SERVICE LETTER 00089

Date Released:	June 17, 2024
Date Effective:	June 17, 2024
Subject:	RV-10 Wing Laser Cut Root Component Replacement
Affected Models:	RV-10 with wings containing the following laser cut parts: W-1010-L/R or W-1010-L/R-1, W-1025B-L/R, W-1029A-L/R, and W-1029B-L/R.
Required Action:	Inspect the area surrounding fastener holes in the laser cut parts for fatigue cracks—cracks propagated beyond the dimple of a flush rivet, or past the head of a universal head rivet. If fatigue cracks are present, replace the affected laser cut parts with punched parts, as outlined in this Service Letter.
Time of Compliance:	Inspect within 200 flight hours or at the next annual inspection, whichever is earlier. If fatigue cracking is not present, you may continue to comply with this Service Letter via ongoing inspection no less than every 12 months or 200 flight hours, whichever is first. Upon or before reaching 1000 flight hours, the alternate fix must be conducted as outlined in this Service Letter, at which point compliance has been met without need for ongoing inspection. If fatigue cracking is present, the modifications required by this Service Letter must be completed before fur

FIGURE 1: LEFT WING ROOT AREA

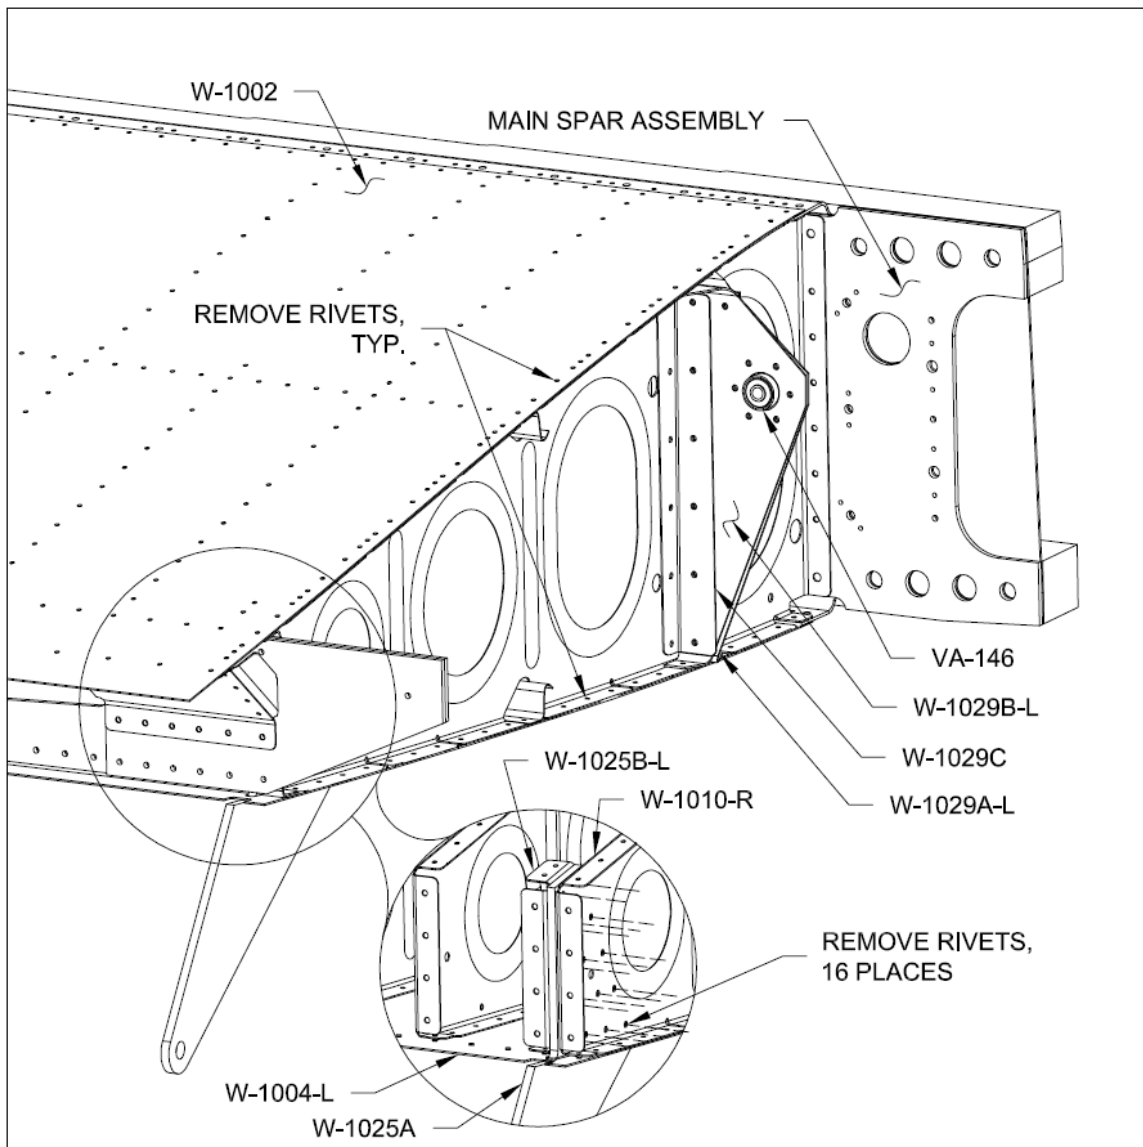
Step 6: Remove rivets fastening the W-1025A to the W-1010-R and W-1025B-L as shown in the detail view of Figure 1. Remove the W-1025A, set aside for reinstallation in a later step.

Step 7: Remove all rivets joining the W-1002 Top Inbd Wing Skin to the W-1010-R, including those common with the W-1029A-L and W-1029B-L. See Figure 1.

Step 8: Remove all rivets joining the W-1004 Bottom Inbd Wing Skin to the W-1010-R, including those common with the W-1029A-L and W-1029B-L. See Figure 1.

Step 9: Remove all fasteners joining the W-1010-R to the Main Spar Assembly. See Figure 1.

FIGURE 2: REMOVING FLAP GAP FAIRING RIVETS

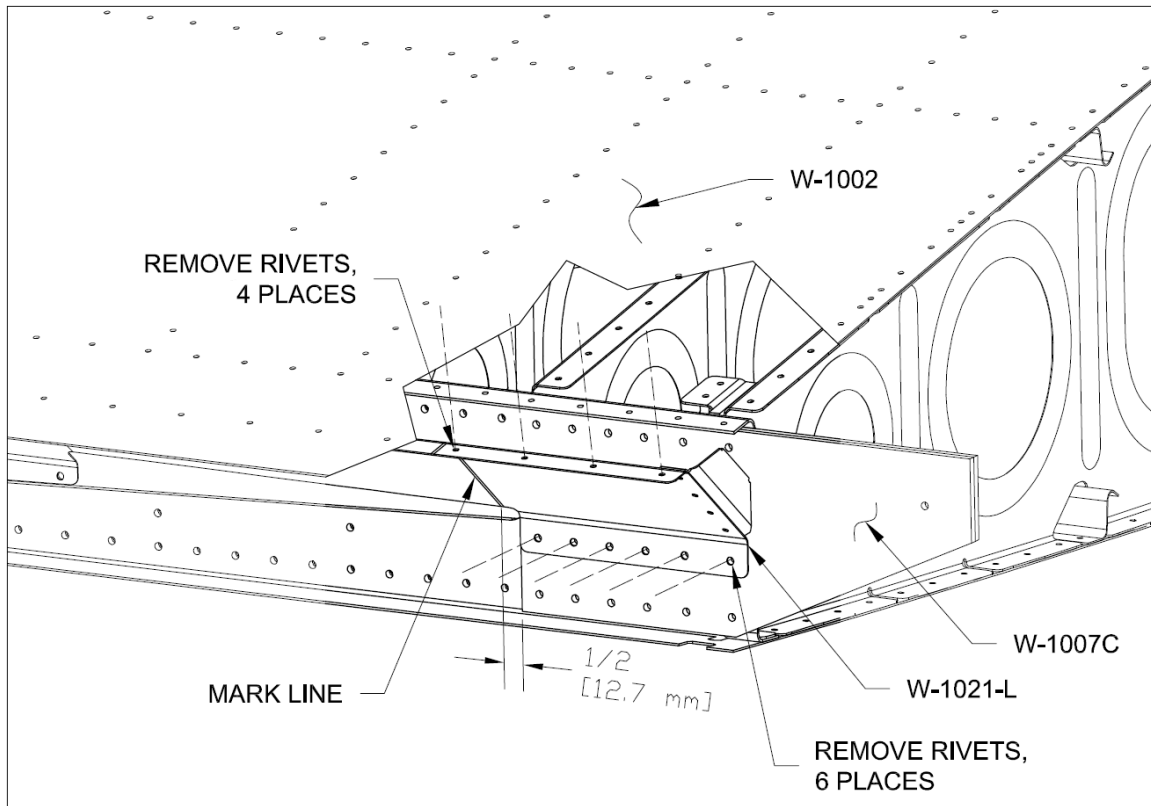
Step 10: Remove the six inboard-most rivets fastening the W-1021-L Flap Gap Fairing to the W-1007C and underlying structure as shown in Figure 2.

Step 11: Remove the four inboard-most rivets fastening the W-1021-L to the W-1002 as shown in Figure 2.

Step 12: Measure and mark a line on the W-1021-L, 1/2 in. [12.7 mm] offset from, and parallel to, the outboard edge of the W-1007C. See Figure 2.

FIGURE 3: CUTTING THE W-1021-L

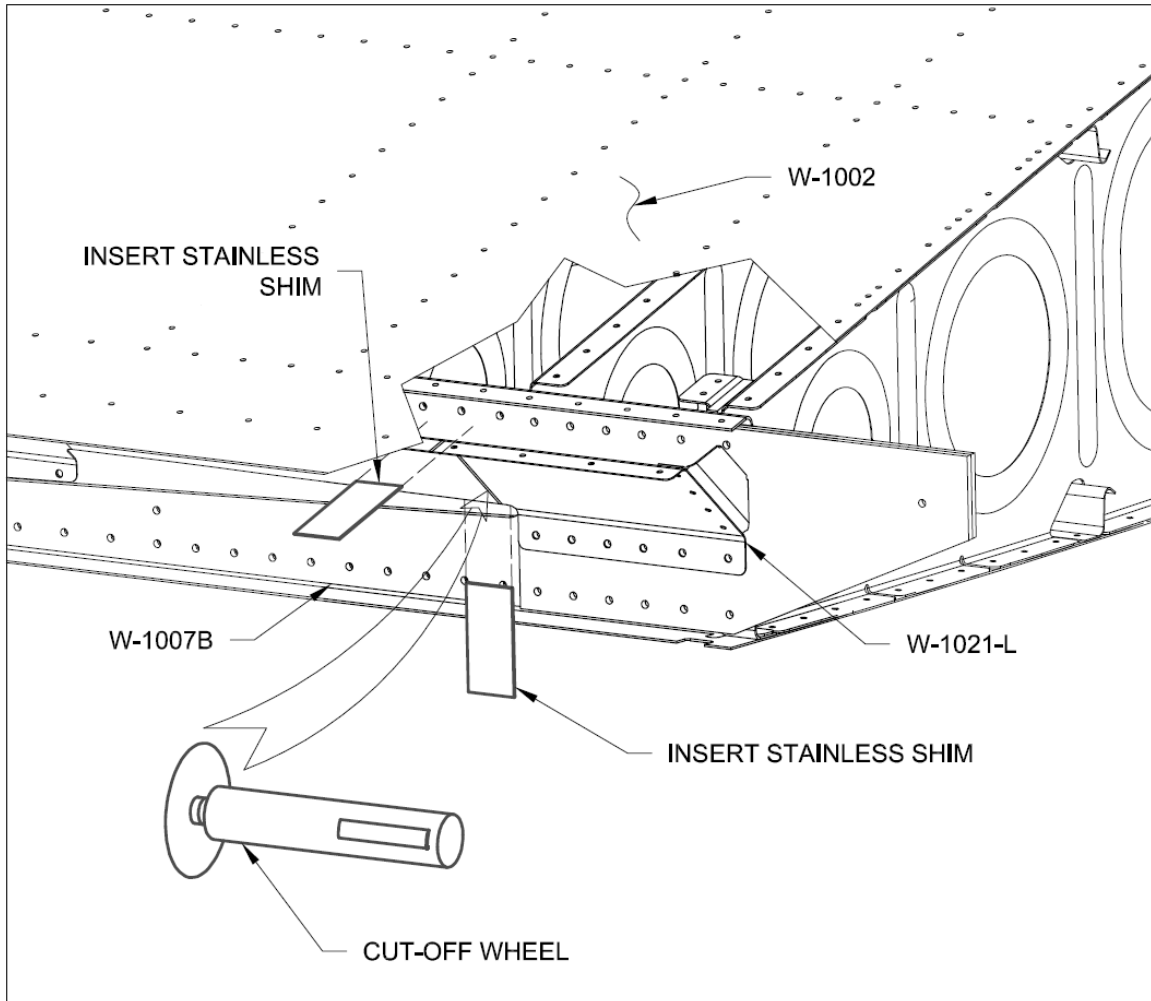
Insert the stainless shims between the W-1021-L and W-1007B, and between the W-1021-L and W-1002 to protect the skin and spar while cutting the W-1021-L in the following step. See Figure 3. If necessary, the stainless shims can be secured with double-sided tape.

Step 14: Being careful to not cut the spar or the skin, use the grinder with an abrasive cut-off wheel to separate the W-1021-L along the line previously marked. See Figure 3.

FIGURE 4: REMOVING REAR SPAR RIVETS

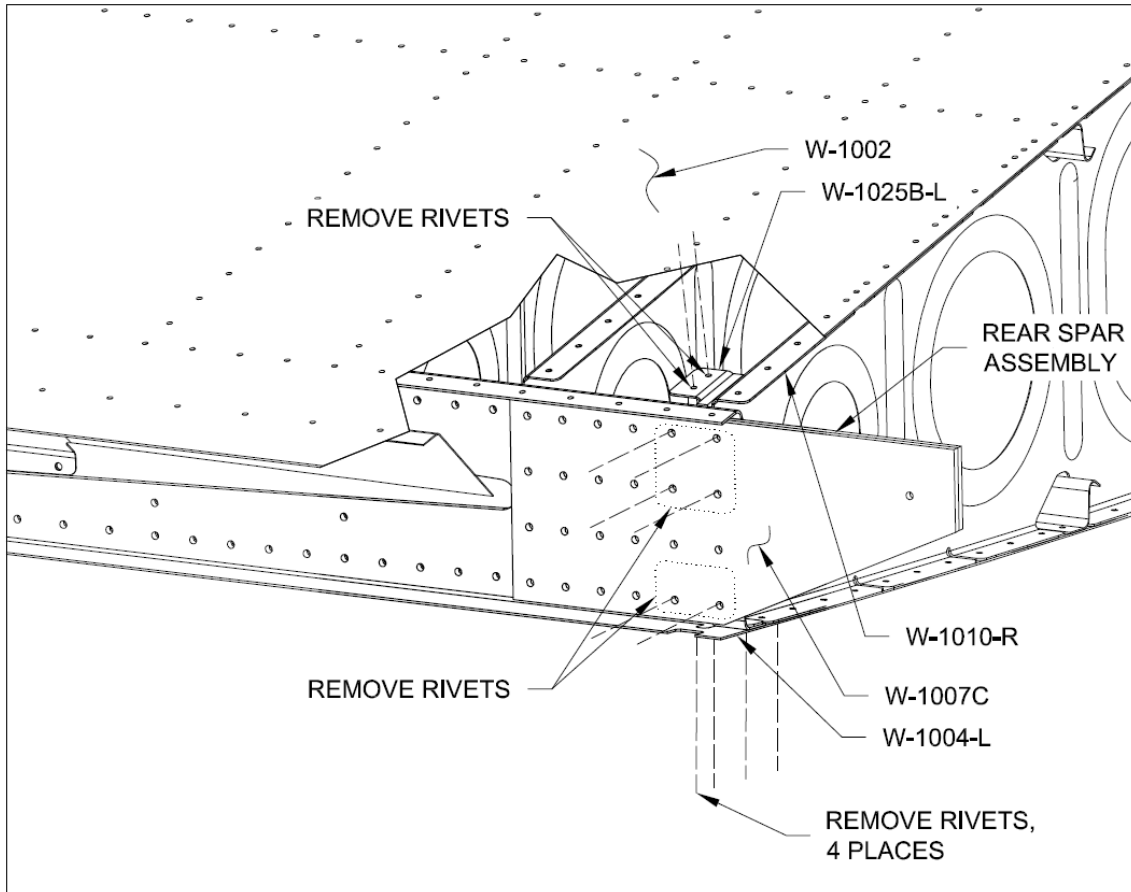
Step 15: Remove all rivets fastening the W-1010-R to the Rear Spar Assembly. See Figure 4.

Step 16: Remove all rivets fastening the W-1025B-L to the W-1002, W-1004-L, and Rear Spar Assembly. See Figure 4.

FIGURE 5: MATCH-DRILLING THE W-1021-L

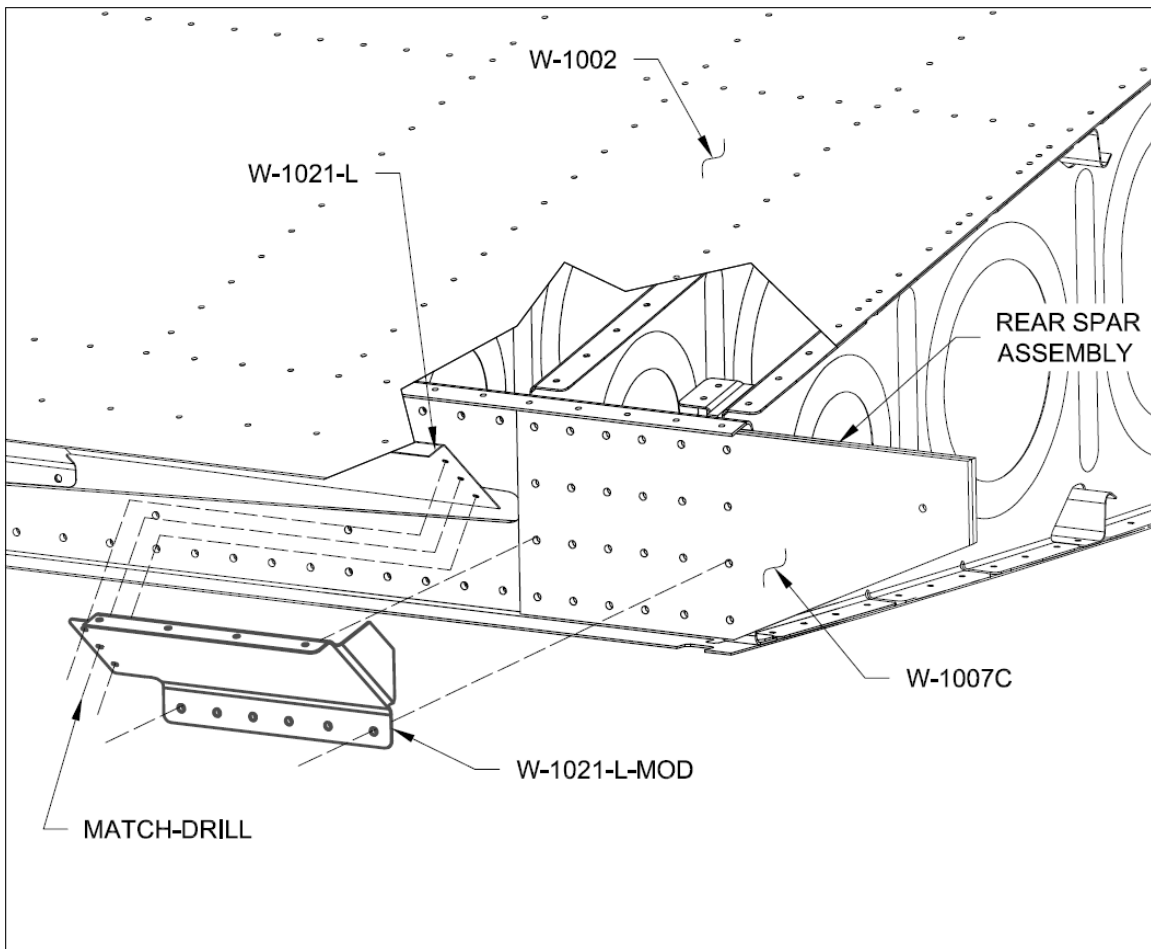
Step 17: Dimple the #40 holes in the top flange, and the #30 holes in the bottom flange of the W-1021-L-MOD, allowing it to nest flush with the W-1002 and W-1007C. See Figure 5.

Step 18: Cleco the W-1021-L-Mod to the W-1007C, and W-1002 as shown in Figure 5. The top flanges of the W-1021-L-MOD and W-1021-L must not interfere with each other when clecoed. Trim away interference of the flanges as required.

Step 19: Match-Drill #30 the three holes from the W-1021-L-Mod into the W-1021-L as shown in Figure 5.

FIGURE 6: TORQUE TUBE SUPPORT BRACKET ASSEMBLY

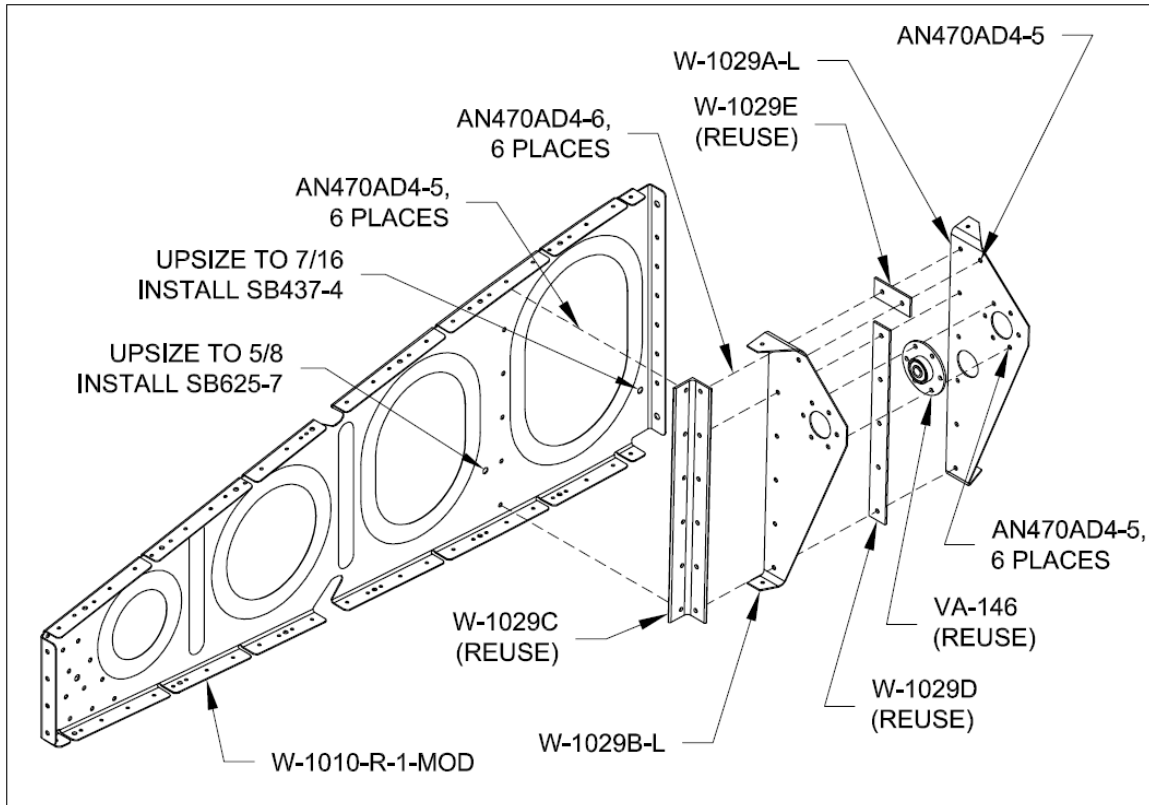
Step 22: Drill out all rivets required to remove the Torque Tube Support Bracket Assembly from the W-1010-R. Continue drilling out all fasteners needed to disassemble the bracket, and set aside the VA-146, W-1029C, W-1029D, W-1029E for reuse. Reference Figure 6.

Step 24: Upsize the tooling holes and install the snap bushings into the W-1010-R-1-MOD as shown in Figure 6.

Step 25: Reassemble and rivet the Torque Tube Support Bracket Assembly with the replacement W-1029A-L and W-1029B-L, reusing the W-1029C, W-1029D, W-1029E, and VA-146. See Figure 6.

Step 26: Rivet the Torque Tube Support Bracket Assembly to the W-1010-R-1-MOD as shown in Figure 6.

FIGURE 7: RIVET CALL-OUTS FOR REAR SPAR AREA

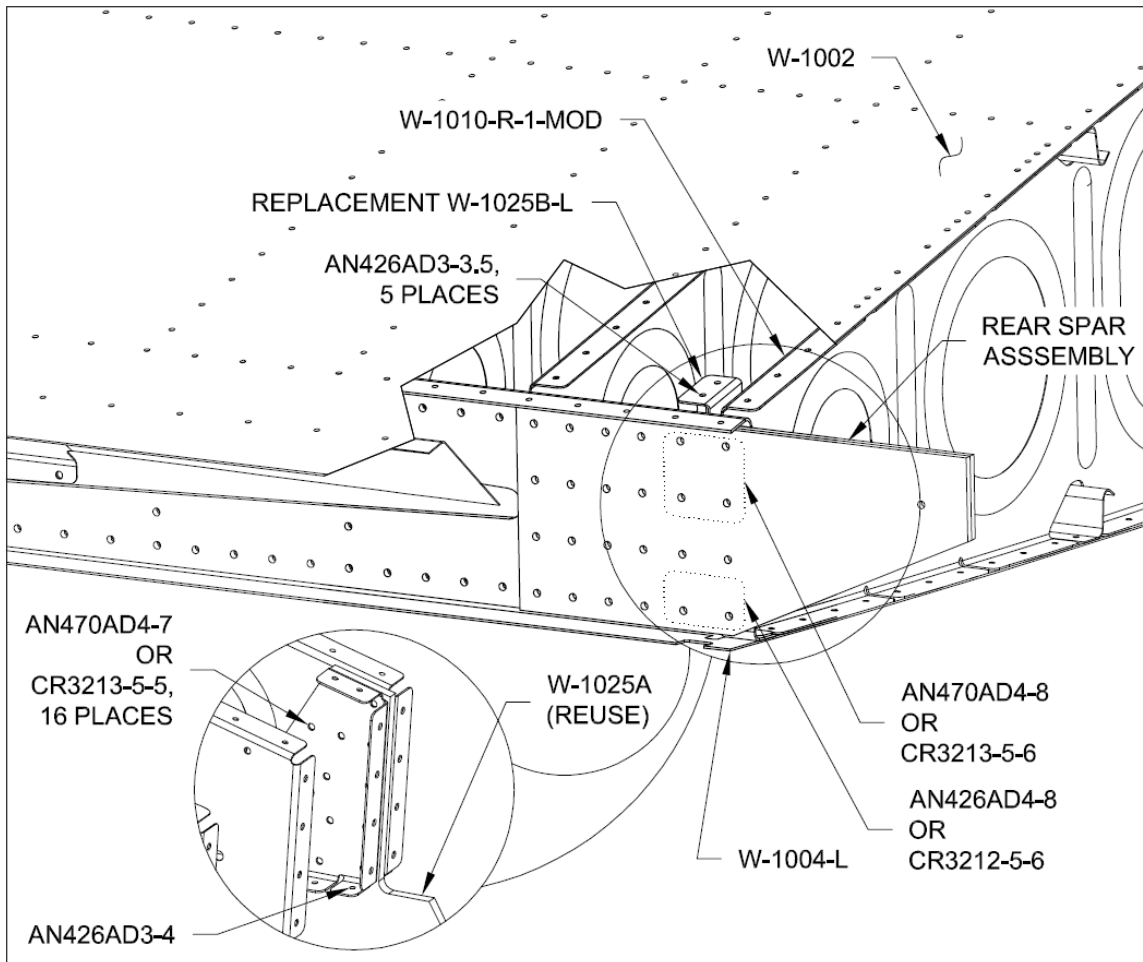
Step 29: Cleco the replacement W-1025B-L into position as shown in Figure 7.

Step 30: Cleco the W-1010-R-1-MOD into position as shown in Figure 7.

Step 31: Cleco the W-1025A into position between the W-1025B-L and W-1010-R-1-MOD. See Figure 7.

Step 34: Cleco the W-1025B-L into the wing, and rivet to the W-1002, W-1004-L, and Rear Spar Assembly as shown in Figure 7. Note the single instance of a longer rivet required in the aft-most hole in the bottom flange of the W-1025B-L as called out in the detail view of Figure 7.

Step 36: Rivet the W-1010-R-1-MOD to the Rear Spar Assembly using the rivets called out in Figure 7.

Step 37: Cleco and then rivet the W-1025A to the W-1025B-L and W-1010-R-1-MOD as shown in the detail view in Figure 7.

FIGURE 8: FLAP GAP FAIRING RIVETS

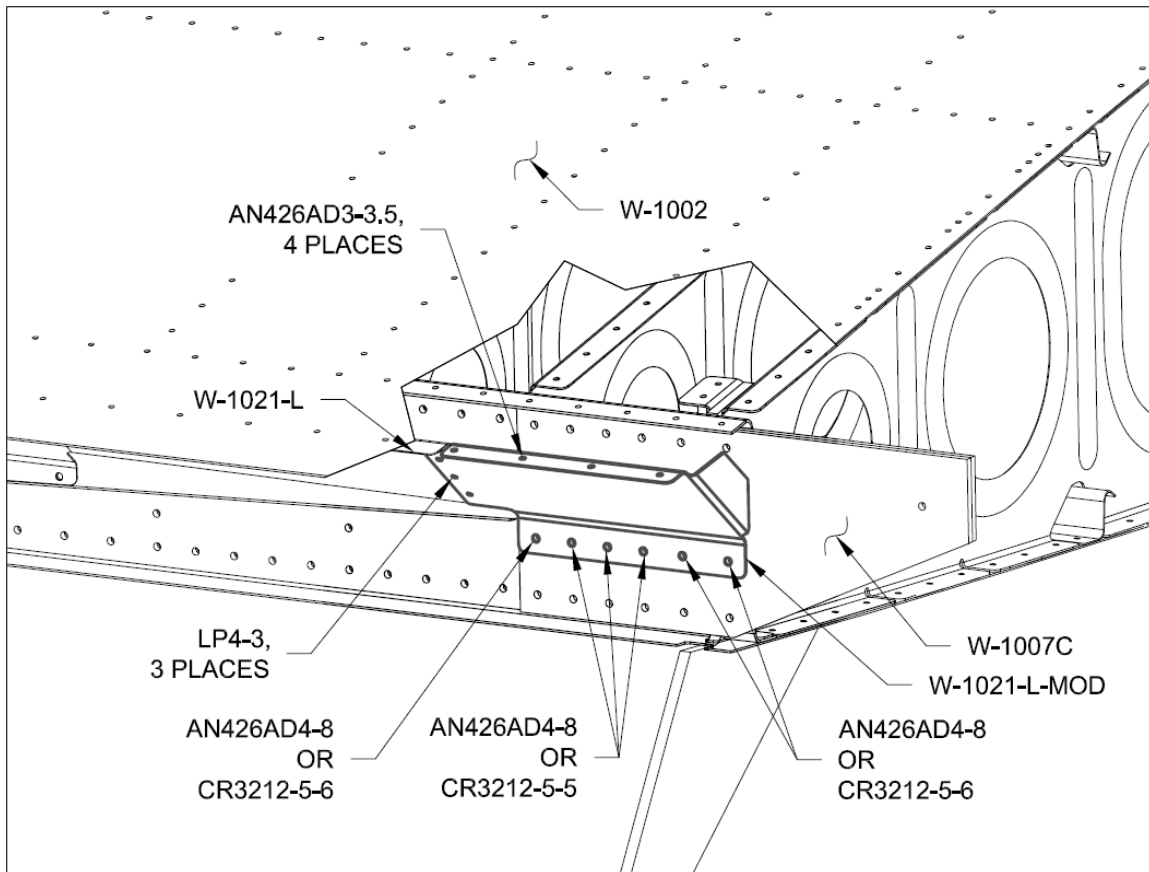
Step 40: Rivet the W-1021-L-MOD to the W-1002, W-1021-L, and Rear Spar Assembly as called out in Figure 8.
